Steel Screw Motorship No.29 building by Messrs. Nakskov Skibs-
erft with a view to class 100A1 "With Freeboard".

The dimensions : 390 x 53.25 x 36 to upper deck.

Scantling numbers : 14040 & 34800

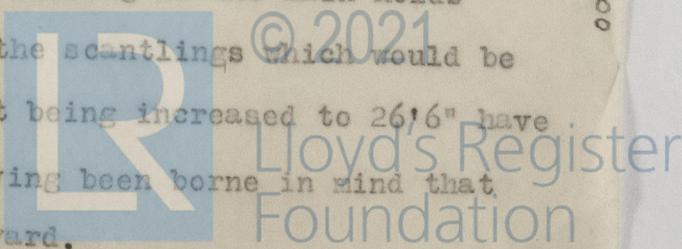
A letter has now been received from the Copenhagen
owners forwarding a further amended plan of midship section
together with a copy of a letter from the Builders in which it
is stated that it is now desired to increase the draught to
2 1/2", and it is also stated that the material is delivered ^{at} ~~in~~
the yard, and the Builders request consideration of the plan
in this view.

The scantlings of the framing in the main holds
and other necessary additions to the scantlings which would be
required on account of the draught being increased to 26'6" have
been indicated on the plan, it having been borne in mind that
the material is delivered in the yard.

It is not clear, however, from the plan of midship section submitted what arrangements of ^{reinforced} framing are contemplated by the Builders in the tween decks, holds and peaks at the extremities of the vessel, and it is considered that the Builder should submit an amended plan of profile and decks showing clearly the scantlings of the framing throughout the various apartments and tween decks. *& comprising all the alterations to date*

It should be pointed out to the Builders that the plans will now require that all the bulkheads should extend to the upper deck.

The Builders should point out to the Owners that the scantlings and arrangements have been determined in accordance with the desired draught and that if at any future time an increased draught were desired it would be necessary correspondingly to increase the scantlings.
